XXXXXXXXXXXX	XXXXXXXXXXXX			XXXXXXXXXXXX	XXXXXXXXXXXX	XXXXXXXXXXXX
Dealer Operator / General Manager	Sales New Vehicles	Sales Used Vehicles	Business Manager (F&I)	Service	Parts & Accessories	Administration
Date: Bulletin #	7/30/2013 SV-ZMC-R-058 Safety recall Code TBD 2011-2012 Zero S and DS Front Brake Caliper Mounting Bolt Replacement	Source: Name: Richard Kenton Title: Dir of Customer Service Phone #: 888-786-9376 ext 43	Zero Motorcycles Aftersales Department		Program Period: 07/29/2013 -11/29/2013

SERVICE BULLETIN (Safety Recall): 2011-2012 Zero S and DS Front Brake Caliper Mounting Bolt Replacement – Recall # 13V-329

Front Brake Caliper Mounting Bolt Replacement

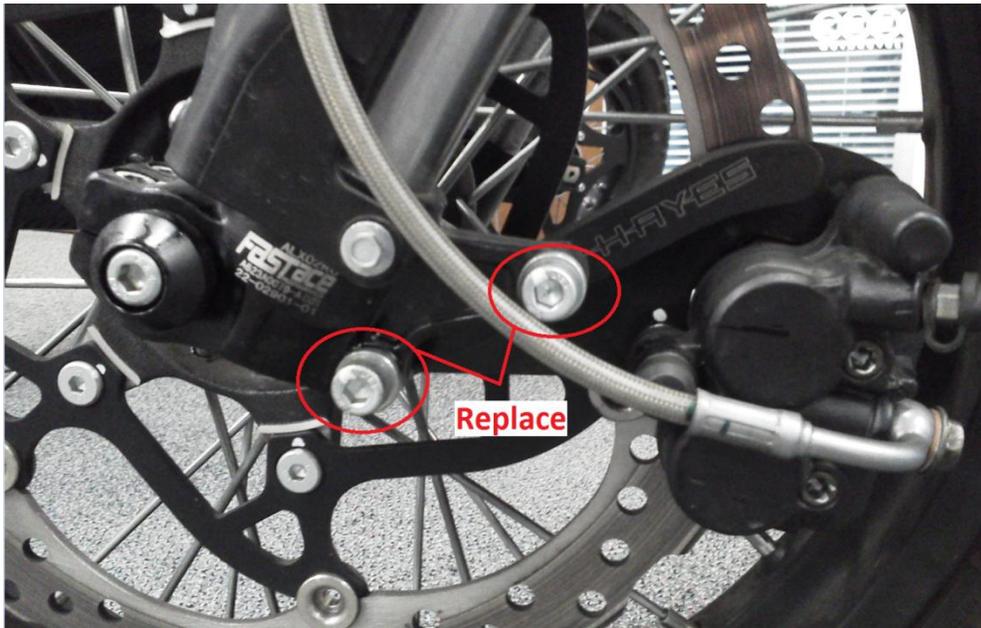
Zero Motorcycles has determined that a defect which relates to motor vehicle safety exists on certain 2011 and 2012 Model Year S and DS motorcycles built on or before March 08, 2012. These motorcycles were built with incorrect grade front caliper mounting bolts that could potentially experience stress corrosion cracking through environmental corrosion, which could lead to their fracture. Should a front caliper bolt fracture, the caliper could come loose and interfere with the rotation of the front wheel. This condition could cause the front wheel to stop suddenly, which could lead to a crash. Zero Motorcycles has voluntarily initiated this recall to correct this condition.

In the interest of motor vehicle safety and customer satisfaction, Zero Motorcycles has elected to initiate a voluntary recall (Campaign 13V-329) to remedy this defect. The remedy of this defect is for authorized Zero Motorcycles dealers to replace the front caliper bolts with new bolts of the intended grade, which is not susceptible to stress corrosion cracking.

- 6mm Allen wrench
- 13mm hex socket
- Torque wrench Torque Setting 19 ft-lbs or 26 Nm

- 10-07024 2011 – 2012 S/DS Front Caliper Bolt Kit – Recall kit.

1. Place the Zero Motorcycle on its side stand.
2. Depending on the head style, use a 6mm Allen or 13mm hex socket wrench to remove the front brake caliper mounting bolts.
3. Inspect and clean leftover Loctite (thread locker) from the caliper mount threads.
4. Using a 13mm socket on a torque wrench install the new 8.8 grade hex head bolts, which are supplied with a pre-applied lock-patch (thread locker). Tighten to 19 ft-lbs (26 Nm).
5. Ask customer to sign recall card and submit warranty claim.
